Re: 49 CFR Part 573; Recall of Mercedes-Benz Rear Seat Cushion ISOFIX Anchor Access

TO: Mercedes-Benz Dealer Principals, General Managers, Sales Managers, Service Managers, Parts Managers	FROM: Thomas Brunner, Department Manager, Vehicle Compliance and Analysis, Engineering Services
RE: Recall Campaign 2014040002- Replace Second Row 60% Seat Pan. Model X166 (GL). Model Year 2014	DATE: April 25, 2014

SUBJECT: **Models X166 (GL), Model Year 2014**
Replace Second Row 60% Seat Pan

Figure 1

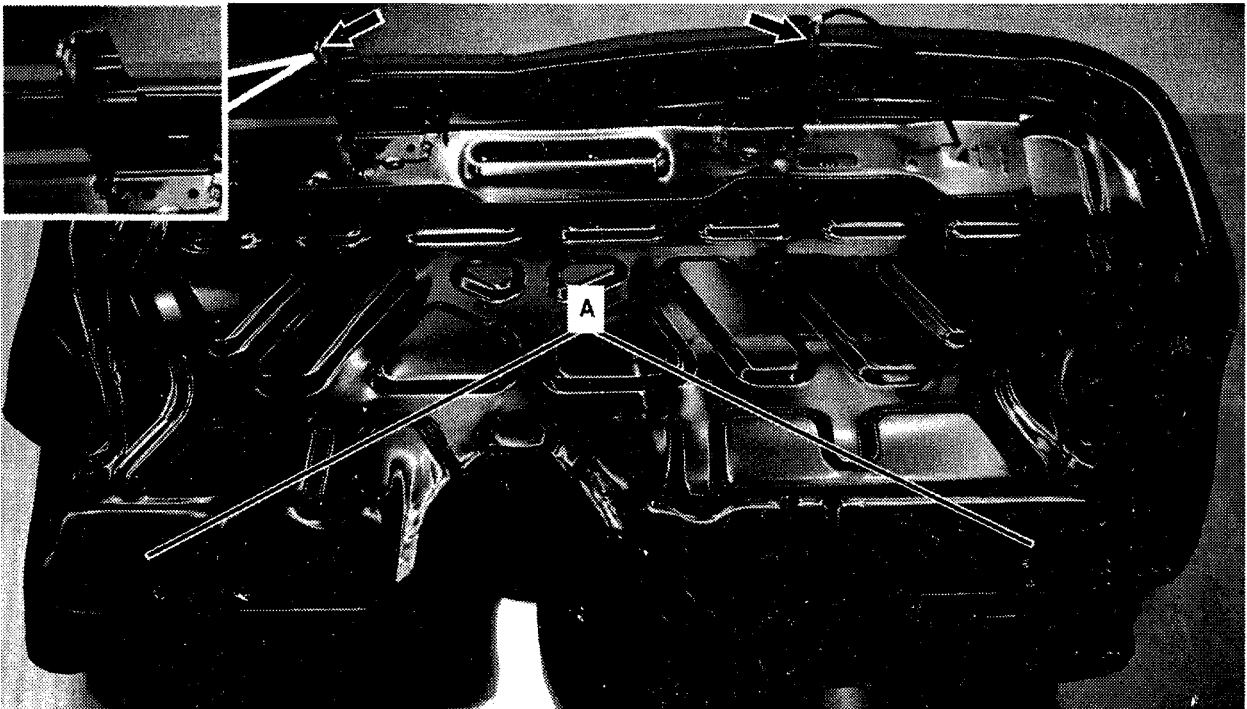
- Be sure to transfer grommets (A, Figure 1) and plastic sleeves with washers (arrows) from "old" seat cushion frame (pan) to "new" seat cushion frame (pan).
 - Reinstall cable tie mounting clip (attached to seat wiring harness) to new seat cushion frame (pan).
 - Secure seat wiring harness to new seat cushion frame (pan) with cable tie.
3.  Assemble in reverse order.
